CITY OF KIRKLAND
Planning and Community Development Department
123 Fifth Avenue, Kirkland, WA 98033 425.587.3225
www.kirklandwa.gov

MEMORANDUM

Subject: COMPREHENSIVE PLAN UPDATE BRIEFING, CAM13-00465, SUB-FILE #9

Figure MB-7: Moss Bay Area Circulation

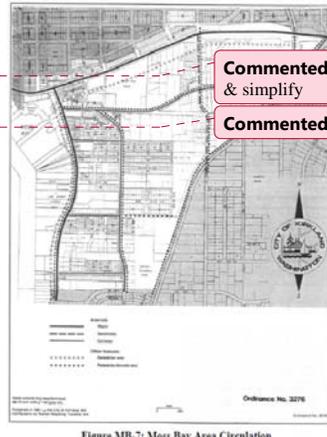
~~In order to minimize the impact of industrial traffic in residential areas, access to industrial uses should follow the routes so designated in Figure MB-7. If industrial access along the west side of the railroad is extended to 6th Street South, then 7th Avenue South should be~~

Commented [JM47]: Not needed, Basic GMA concurrency requirements

Commented [JM48]: MB 7 does not show routes

- (3) Major pedestrian and bicycle pathways should be enhanced according to Figure MB-7.

Figure J-6: Juanita Street Classifications

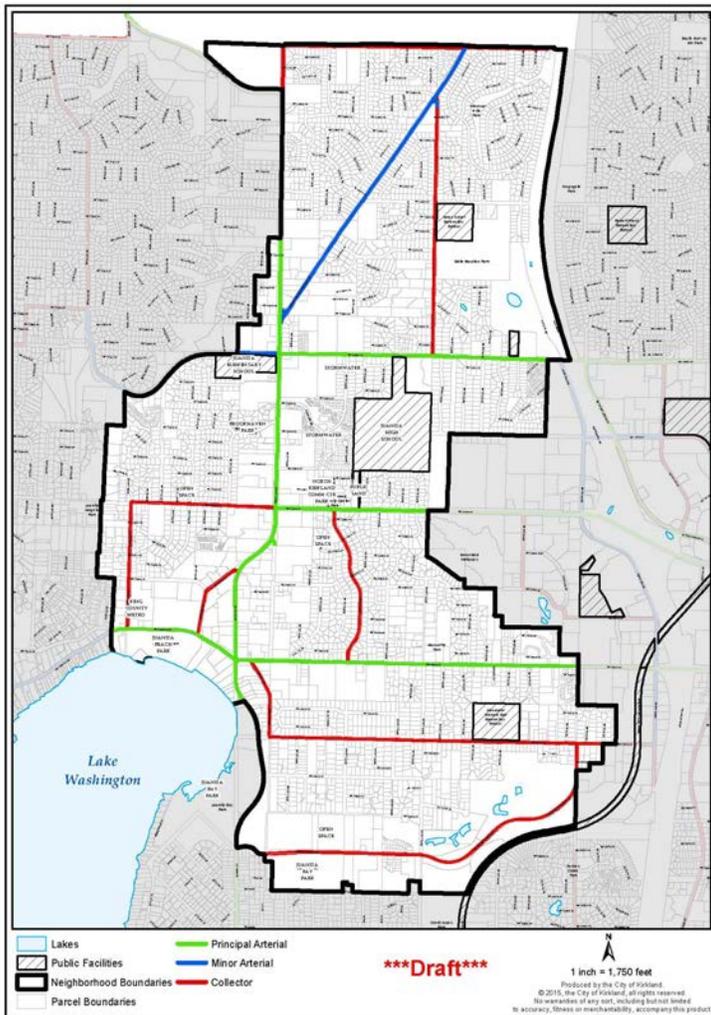
Commented [JC8]: This text is deleted because the Kingsgate Park and Ride property is proposed to be added to the Totem Lake Neighborhood.

Figure BT-7: Bridle Trails – Urban Design Elements *(insert revised figure)*

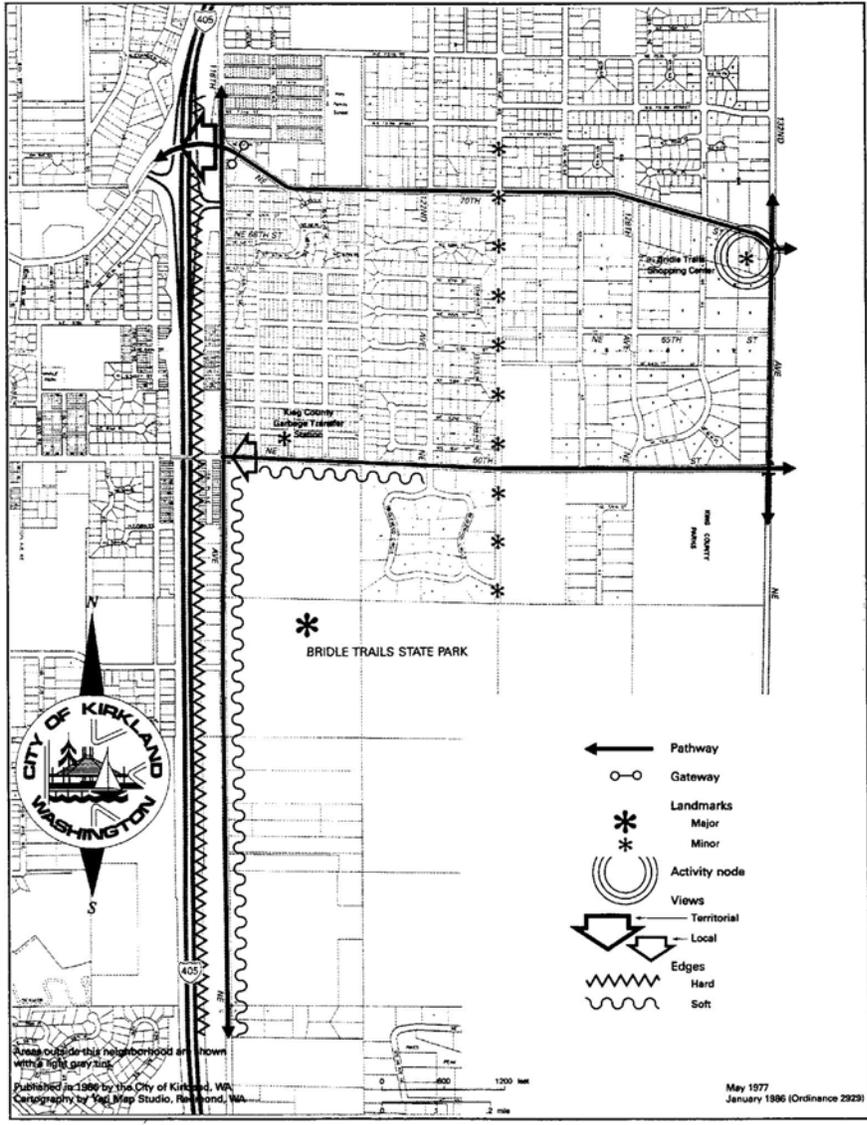
Commented [JC15]: Views no longer exist because of existing trees at Everest Park
